Bournemouth, Christchurch, East Dorset, North Dorset and Salisbury SFRA

From: Jonathan Maidman <Jonathan.Maidman@dorsetcouncil.gov.uk>
Sent: 29 October 2025 14:42
To: Charlotte Whitham
Subject: Re: SHF.284.013 - Gundrys Farm Caravan & Camping, Wimborne (LLFA)

Enzygo have been commissioned to undertake a Flood Risk Assessment [FRA] for a planning application for a touring holiday caravan development, located on land at Gundrys Farm Caravan & Camping, Wimborne.

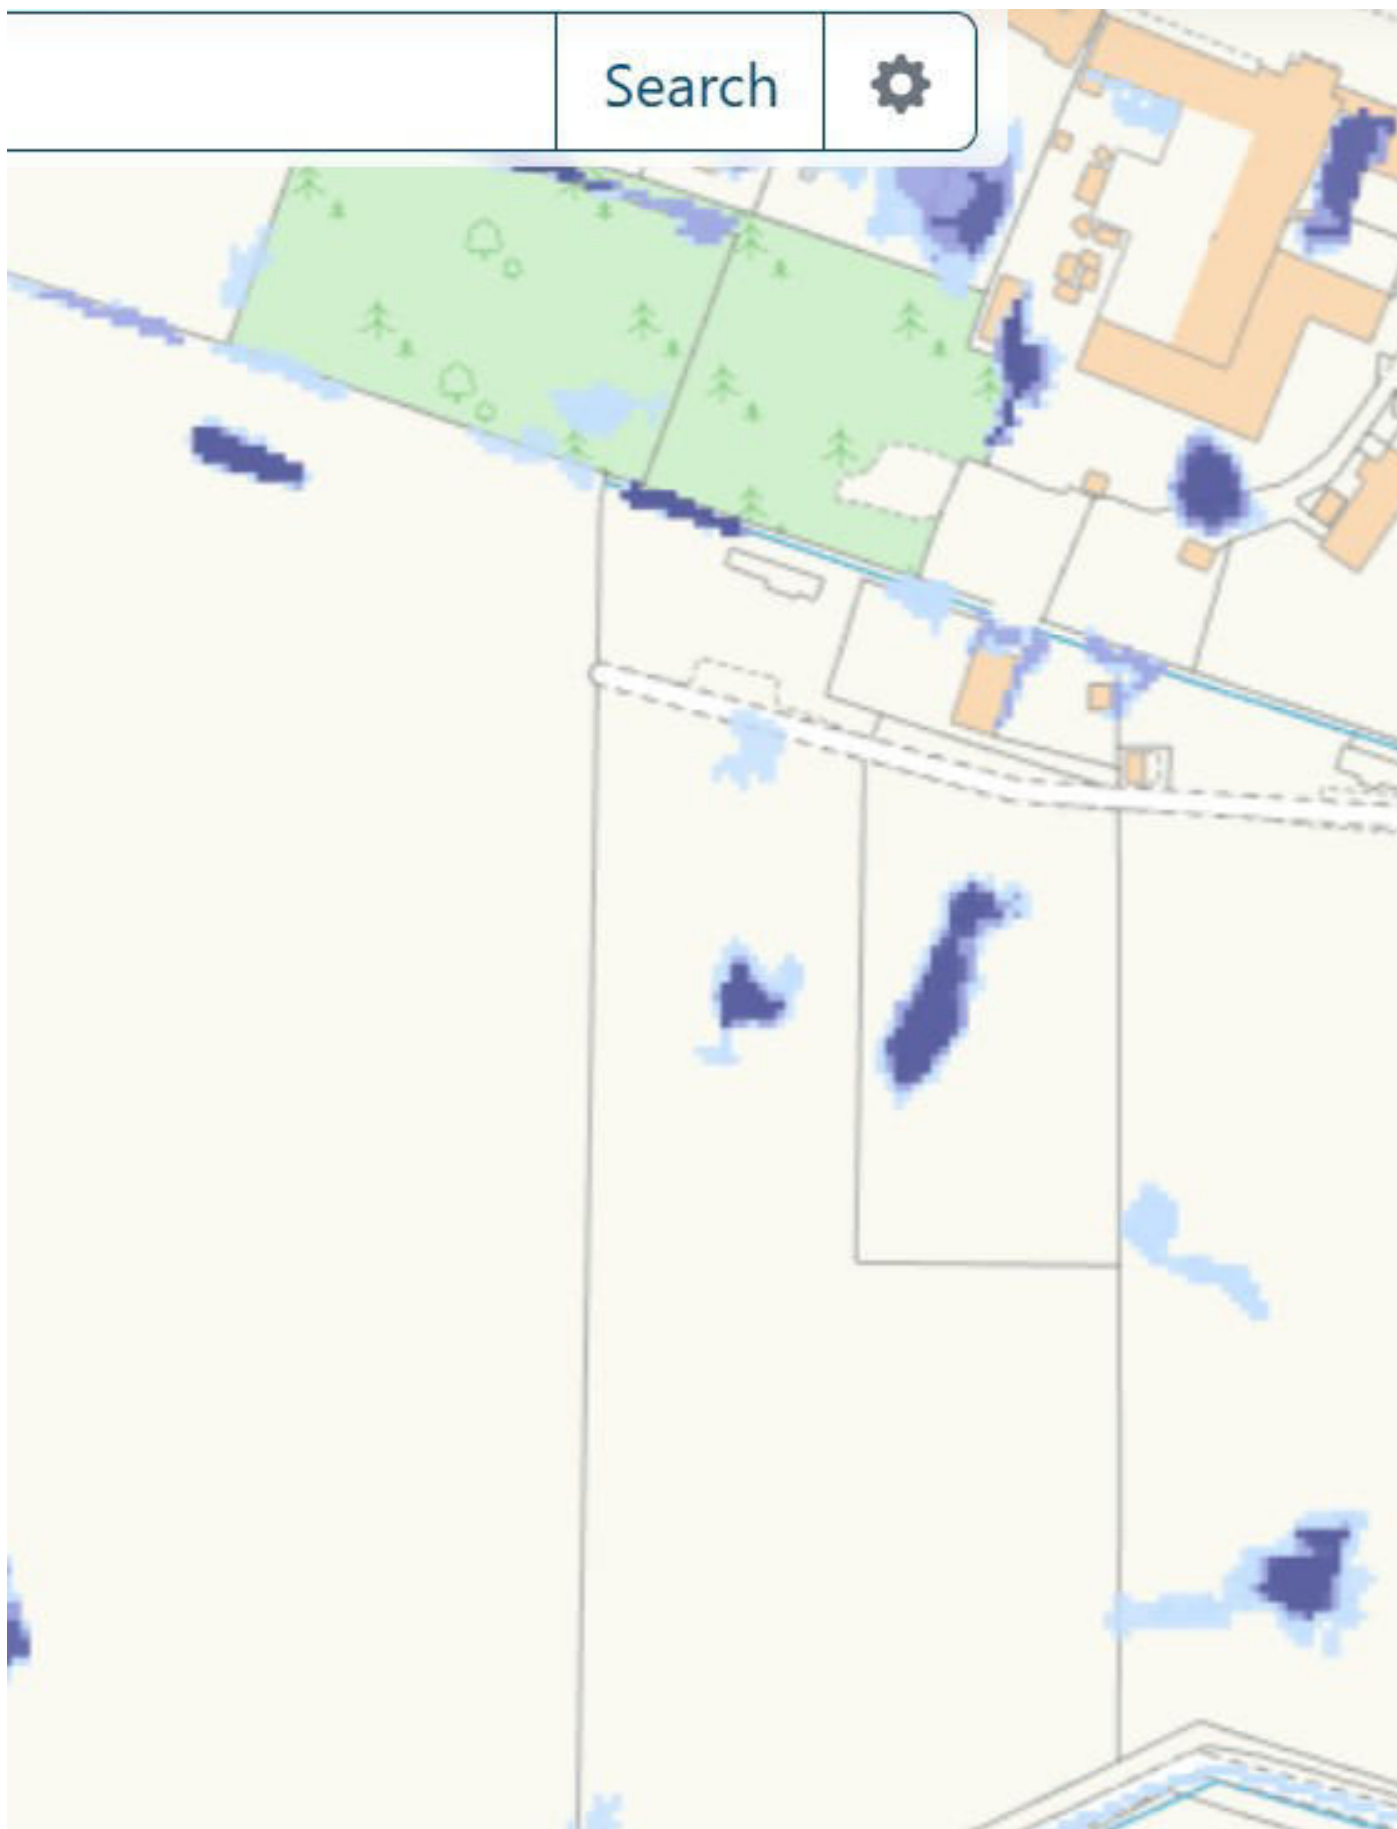
Do you agree with our above interpretation of surface water flooding?

Some areas of the site are identified as being susceptible to surface water flooding which I presume corresponds with lower points on the land. We would generally recommend any development to be outside of such areas, particularly those identified as being in the 1:30 and 1:100-year events.

You should also take account of climate change as per the extract below, however it is only marginally different from the maps you have included in your previous e-mail;
